Title: ISOTHERMAL OPERATION OF HETEROGENEOUSLY CATALYZED THREE PHASE REACTIONS

Appeal No: 2008-1715
Application: 09/629,482
Appellant: Franz Josef Brocker et al.

Reply Brief under 37 C.F.R. § 41.41

EXAMINER'S ANSWER

FIG.4

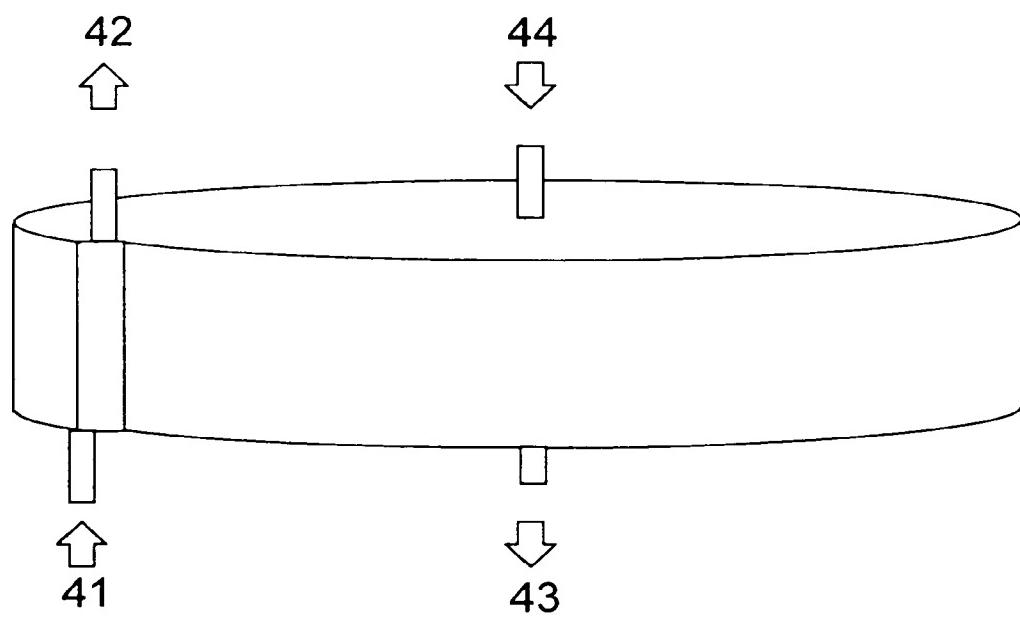
In the present invention, heat transfer is provided by a heat exchanger, for example, as described in the specification as comprising a plate type heat exchanger or a spiral type heat exchanger, which, as illustrated in FIG. 4, utilizes a counter-current flow, albeit co-current arrangements are also disclosed. On the other hand, Arganbright does not disclose cooling systems, e.g., countercurrent type heat exchangers, but rather, discloses, “[t]he temperature of the reactor is determined by boiling point of the liquid mixture...To change the temperature the pressure is changed. Temperature in the reaction zone is thus controlled by pressure; by increasing the pressure, the temperature in the system is increased, and vice versa.”

FIG. 1

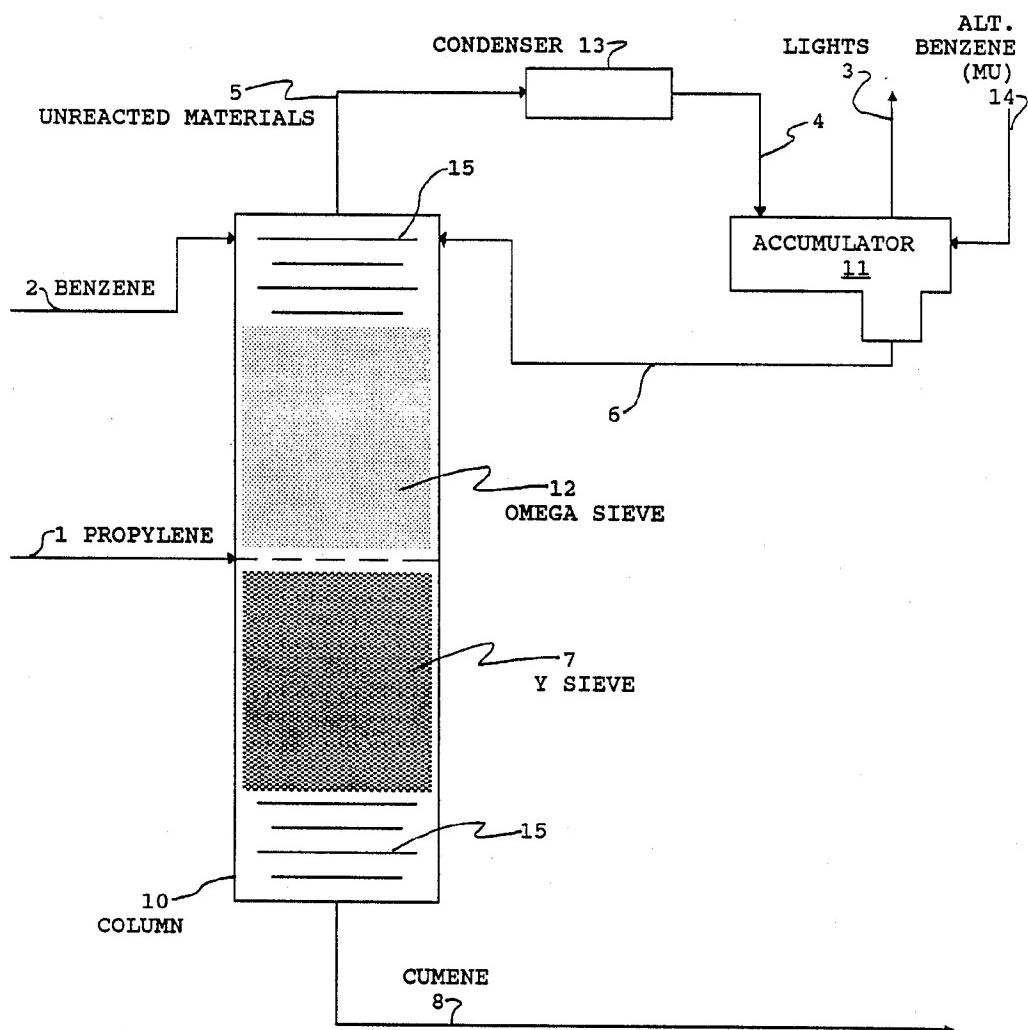
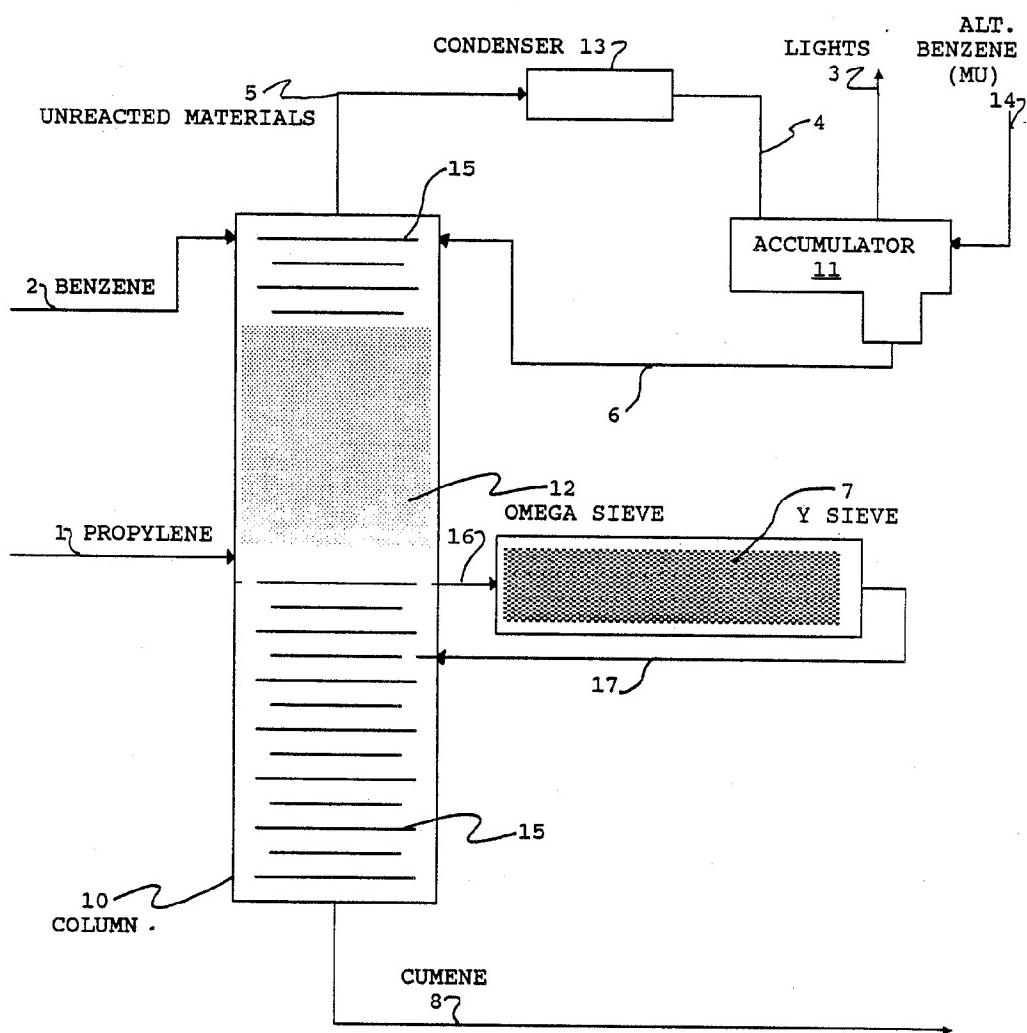
Thus, contrary to the examiner’s statement that the claimed step “must be recognized when on[e] having ordinary skill in the art see [sic] figure 1 in which unreacted materials as a gas go out [sic] the reactor via stream 5 and cumene as a liquid flow down stream

On column 7, lines 24-34, Arganbright discloses that the benzene and others flow down to the bottom of the Omega sieve section to the Y sieve section. In figure 1 and 2, the examiner has recognized that gas propylene stream 1 must be dispersed into this flowing down benzene stream before the mixture of benzene and propylene reacted further in the Y sieve.

The argument that there is not intentional step of generating a reaction fluid by dispersing a gas phase in a liquid phase is not persuasive since as shown in figure 1 and in the abstract, propylene gas stream 1 must be dispersed into the downstream benzene (stream 2) before the mixture benzene and propylene reacted further in Y sieve zone. Appellants also argue that as described in the specification, the dispersing step of gas phase in the liquid phase can be performed by a dispersing elements such as a liquid jet gas compressor, jet pumps for conveying and compressing gasses. However, applicants do not claim using these dispersing elements.

The argument that claim 11 requires a step of ‘separating the reaction fluid into gas phase and liquid phase’. This step must be recognized when one having ordinary skill in the art see figure 1 in which unreacted materials as a gas go out the reactor via stream 5 and cumene as a liquid flow down stream 8.

On the one hand, the examiner argues that propylene “must be dispersed” into any down-flowing benzene stream, and that therefore some sort of pseudo-reaction fluid is generated in the Arganbright et al. reactor. On the other hand, the examiner argues that this pseudo-reaction fluid passes through the reactor without substantial change in the degree of the dispersion. Unless the examiner also takes the position that the pseudo-reaction fluid is generated instantaneously, both arguments cannot be true. Assuming for the sake of argument that propylene is dispersed into a down-flowing benzene stream, a skilled artisan would not expect such dispersion to occur instantaneously, but would expect the propylene to be dispersed gradually, if at all. If the dispersion occurs gradually, it is clear that the degree of dispersion changes through the reactor, and that the Arganbright et al. reference does not teach “passing the generated reaction fluid, without substantial change in the degree of the dispersion of said reaction fluid, through a reactor.”
